COLLIN COUNTY, TEXAS

ADDENDUM No. Two (2)

IFB NO. 2014-261

Construction, Collin County Walking Trail

**REINFORCED CONCRETE SIDEWALKS
JOINTS AND SPACING
PAVEMENT SYSTEMS**

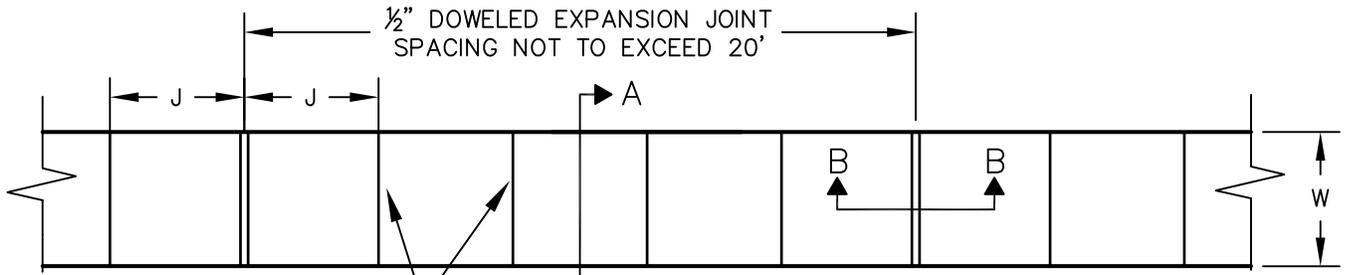
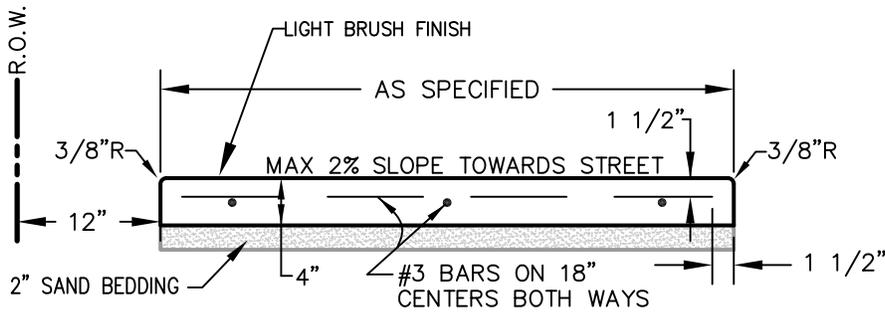
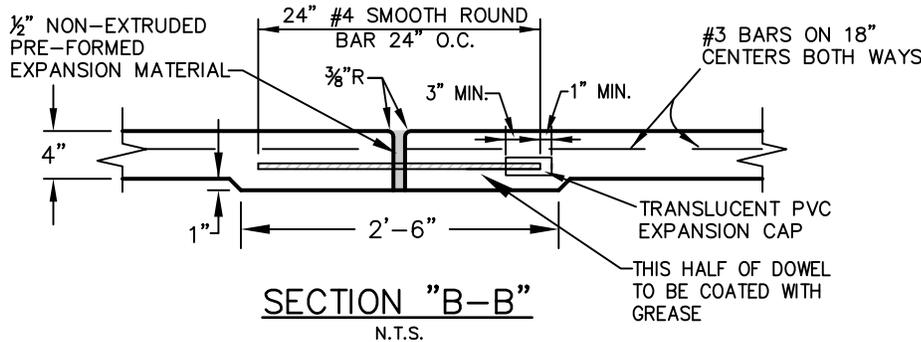
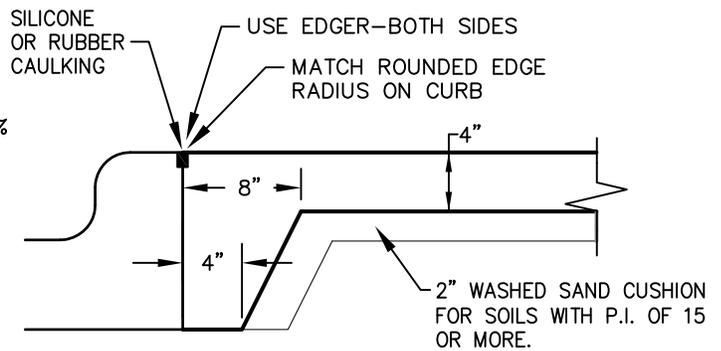
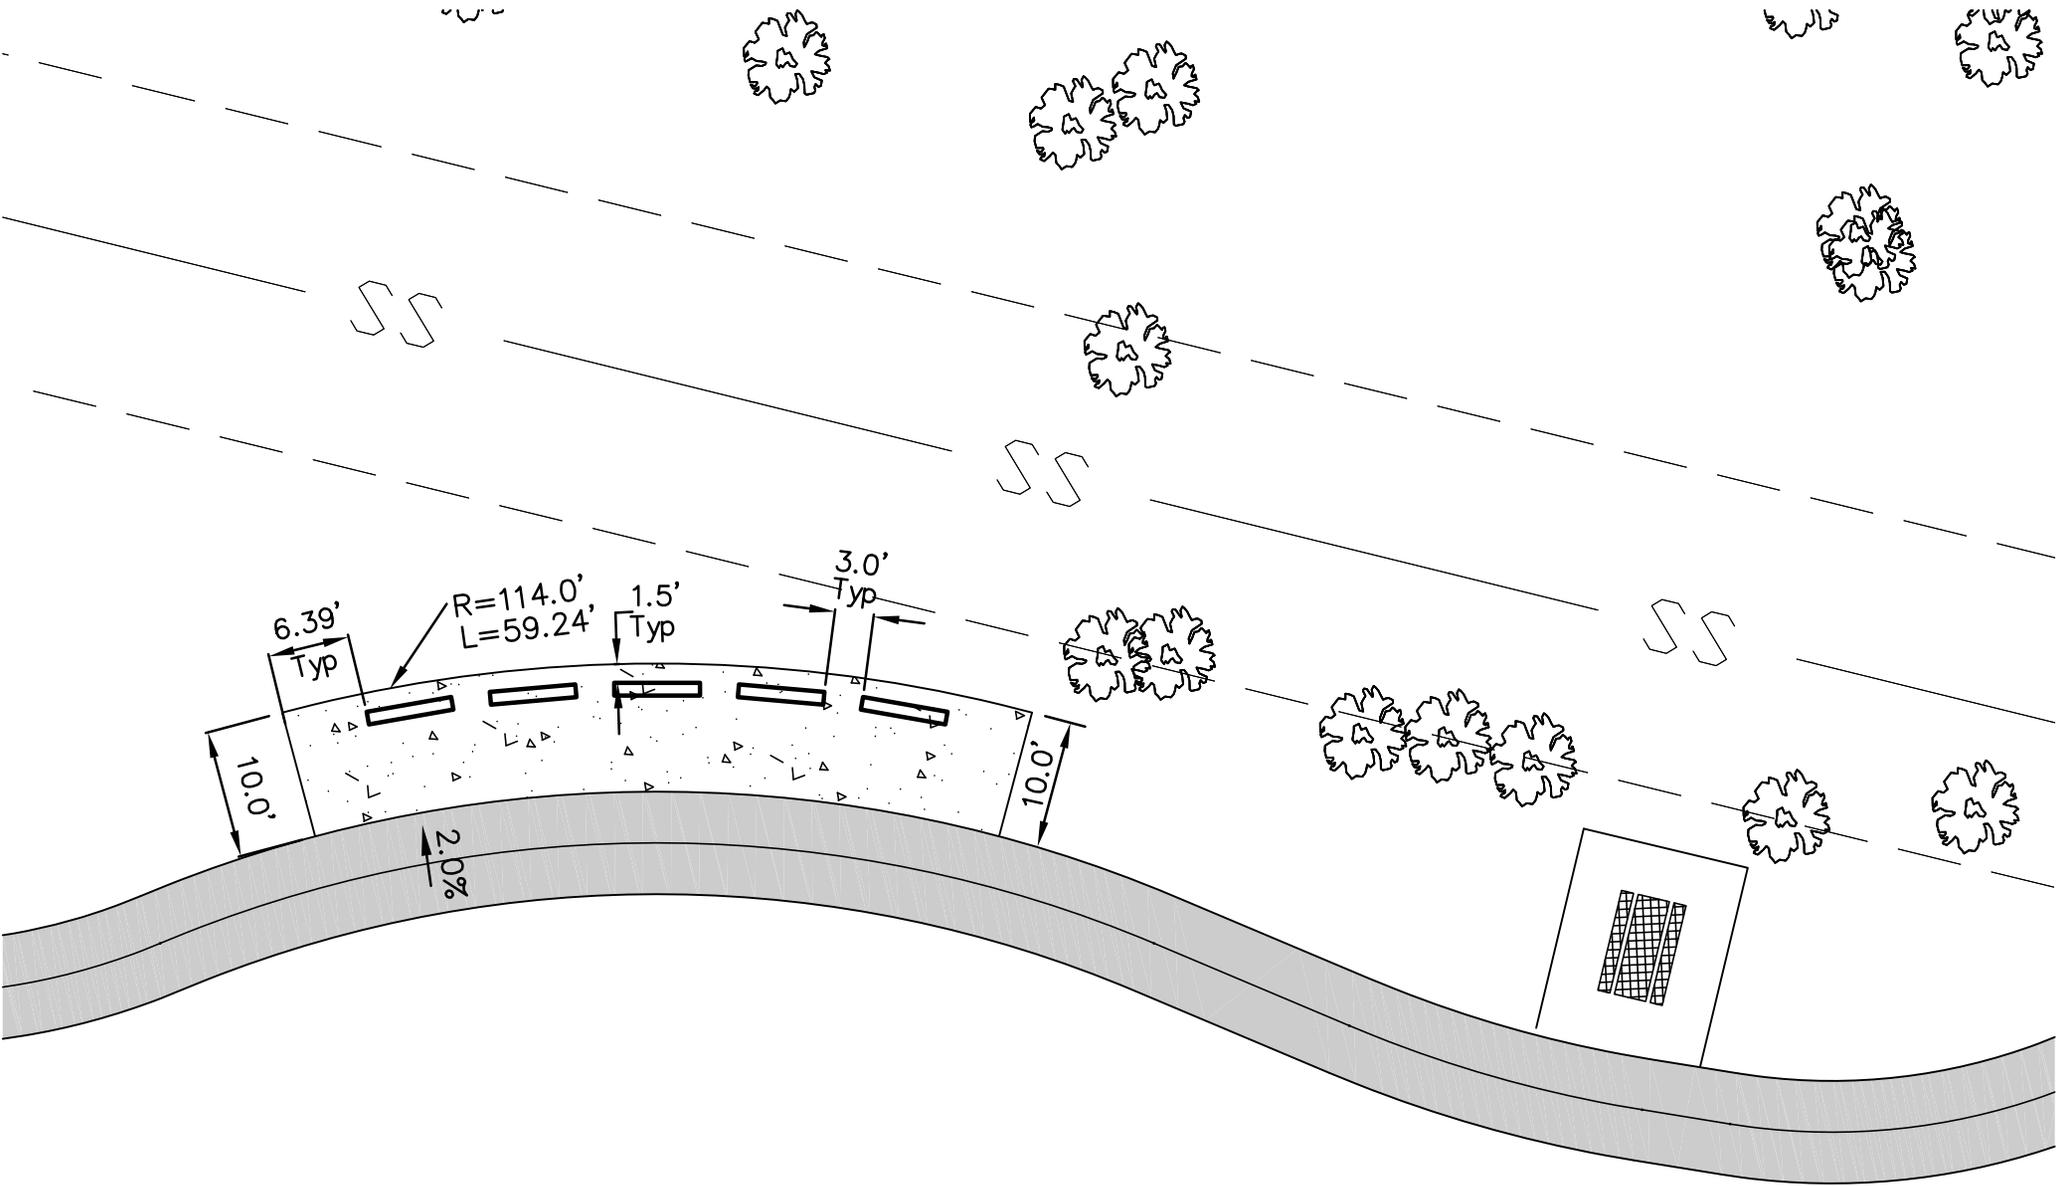
Item 29: Sheet C9; Notes on concrete joints refer to "Reinforcing Bars Shall Be Supported By Approved Device". What is this device and where can it be referenced?

- A. Reinforcing bar support devices shall be chairs or ties complying with "Reinforced Concrete Sidewalks-Joints and Spacing" per City of McKinney, refer to attached PDF file "McK Sidewalk Stds."

1 HANDRAIL DTL
 1" = 1'-0" RAMP-UPPER LANDING

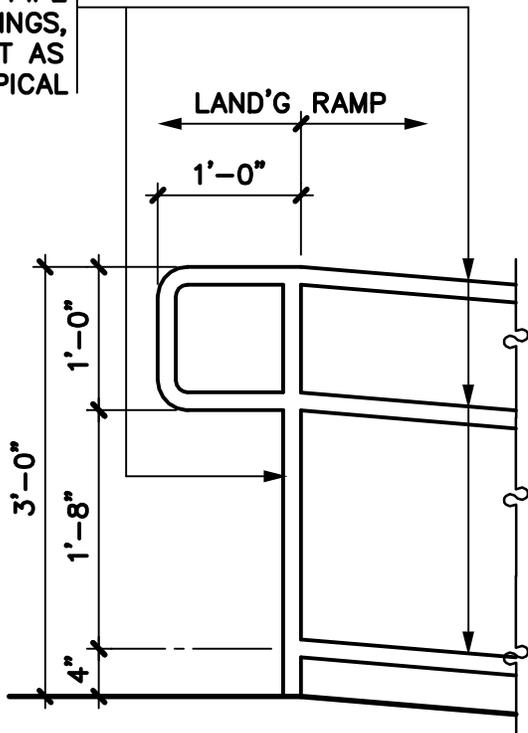
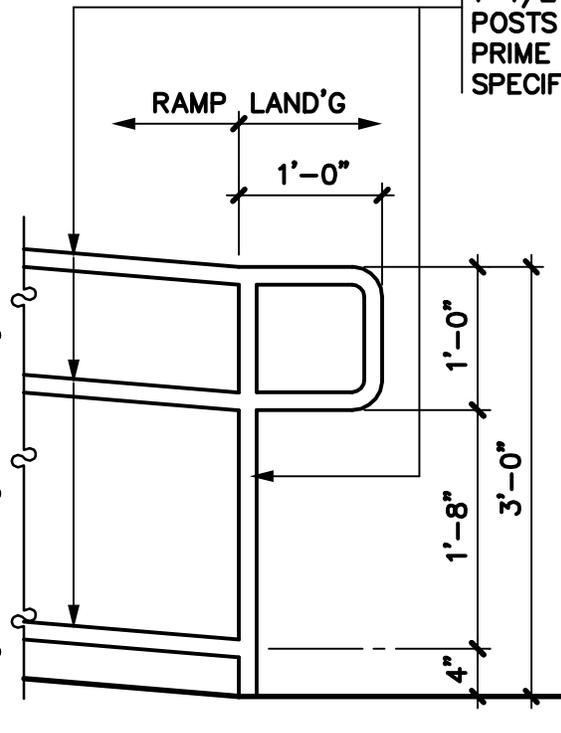
Item 4: Sheet C3; note reads "See Arch Plans for Railing and Details" but there is no detail for railings in the Drawings.

- A. Refer to attached PDF file "Ramp Handrail Detail" for typical details at upper and lower landings of ramp sections.

SIZE B	Drawing name	REV
	Drop in bollard install

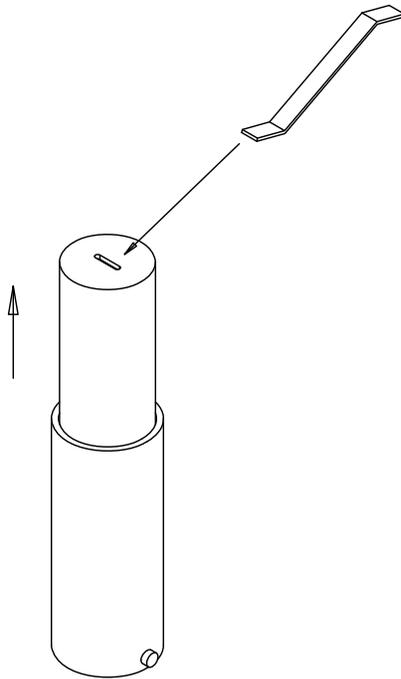
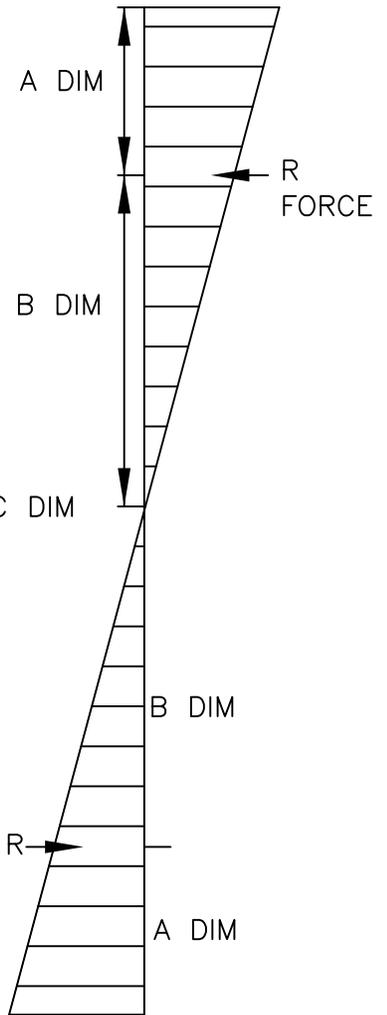
Item 1: Sheet C2; note reads "Removable Bollard" but has no specification for bollard or installation details.

- A. Refer to attached PDF file "Removable Bollard Details" and provide bollard complying with Chart line 8, 10,000#, 5.563" outside diameter, 5.047" inside diameter and 66" pier height 'C'.
- B. There shall be one (1) bollard where shown on Sheet C2 near the Administration Building end of the trail and one (1) bollard at Bloomdale Road end of the trail near STA 9+73.63 shown on Sheet C5, both under the Base Bid.
- C. There shall be one (1) bollard at the Sheriff's Office end of the trail near STA 0+00.00 shown on Sheet C3 under the Alternate Bid.

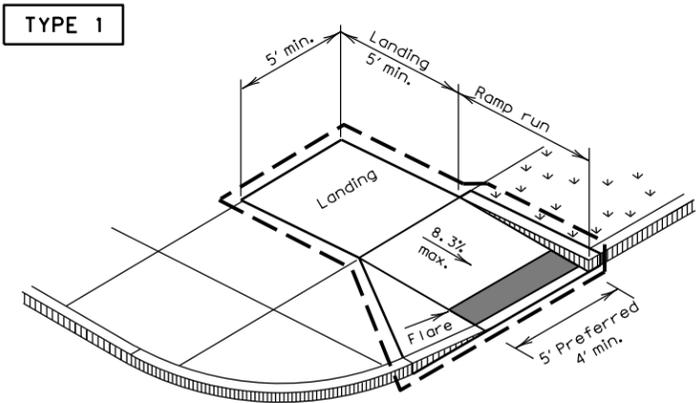
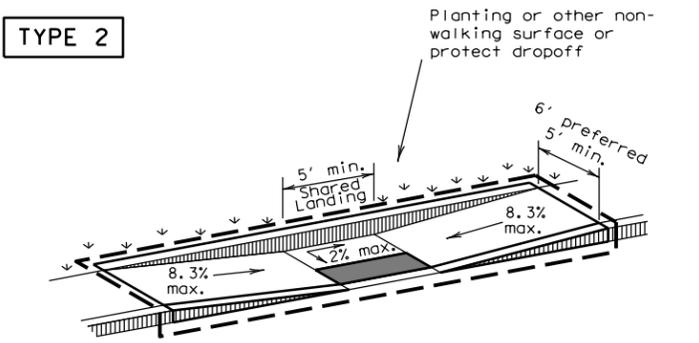
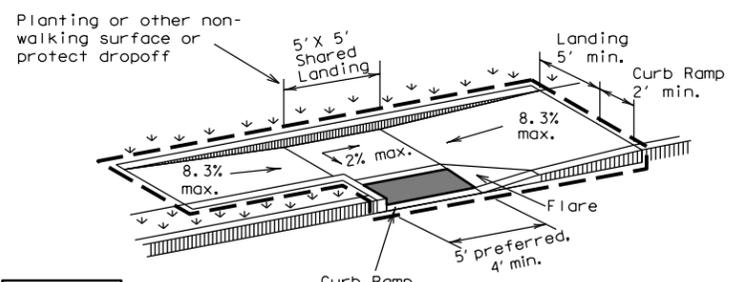
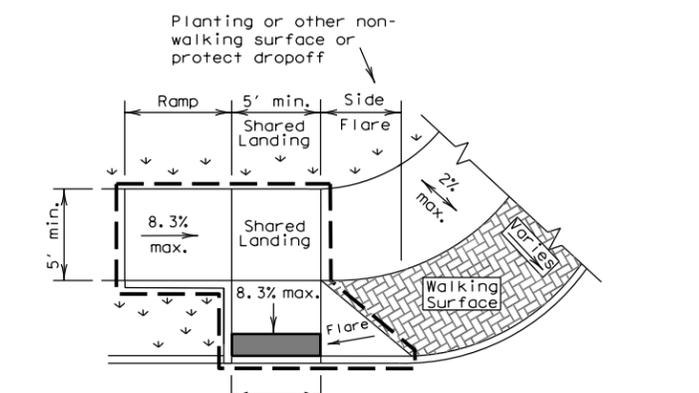
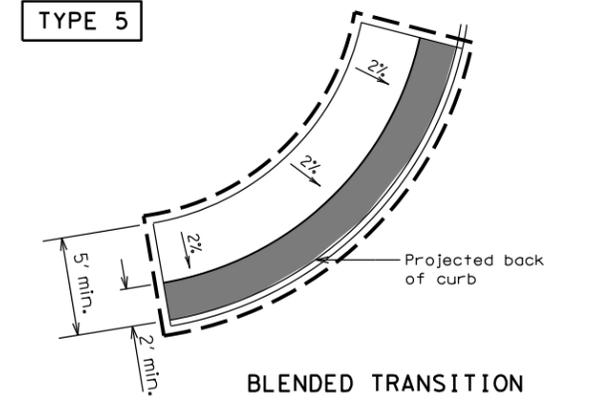
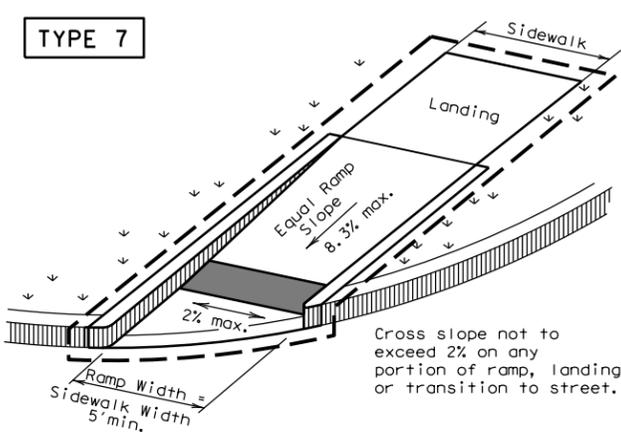
Item 9: Sheet C4, I'm not sure what BFR stands for but I assume it is for an ADA pathway but there is no detail for constructing the ADA access.

- A. BFR is Barrier Free Ramp; refer to attached PDF file "TxDOT Curb Ramp Details". Barrier Free Ramps shall comply with Type 7 ramp.
